TENNESSEE VALLEY AUTHORITY

April 27, 1982

WATTS BAR NUCLEAR PLANT UNITS 1 AND 2  
SHEETPILE WALL SAFETY FACTORS

WATTS BAR NUCLEAR PLANT UNITS 1 AND 2  
SHEETPILE WALLS

Figure 1: Procedure to estimate bending moment in sheetpile wall.

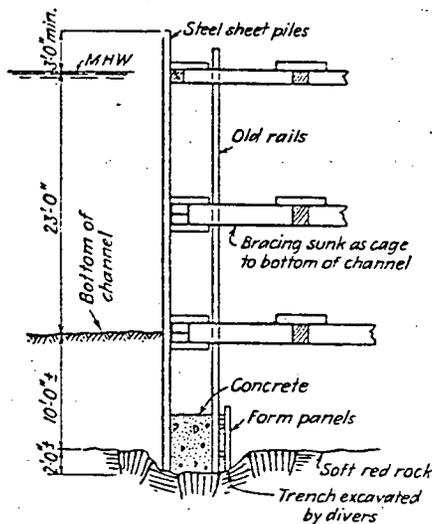
A description of the method of static and dynamic analysis of the tieback sheetpile walls, and the results of the analysis should be promptly provided by the applicant for staff review. The applicant should include in the FSAR a list of soil-related parameters, including anchorage used in the design, the design values of these parameters, and the bases for obtaining the design values used in the analysis.

The static loads of the required load cases were calculated following the method presented in Chapter 11 of Foundation of Structures by C. W. Dunham, McGraw-Hill, 1962. The applicable portion of this text is presented in figures 1 and 2. A value of 210 psf per foot of depth was used for the unit passive pressure (Pn) and 32 psf per foot of depth was used for the unit active pressure (Pa) in the calculations.

When the embedment of  $DB$  is considerable, it can support the shear at the bottom of the piling, and perhaps fix that end against rotation. In this case, the bending moment at  $Q$  and in the portion  $QB$  may be estimated in the following manner, referring to Fig. 11-13(b):

1. Assume the active-pressure diagram to be the rectangle  $QUEB$ .
2. Assume the passive-pressure diagram to be the triangle  $DVB$ , where angle  $\alpha$  represents  $p_n$  p.s.f. per ft.
3. Assume that the passive pressure will be developed as rapidly as possible to support the piling. Excessive length of  $DB$  over that required will be assumed to fix the piling in position but not to add materially to the reaction or the bending moments.
4. Find the distance  $x$  such that the minimum passive resistance  $DV'B'$  will support one-half of the pressure caused by the diagram  $QUE'B'$ . Thus
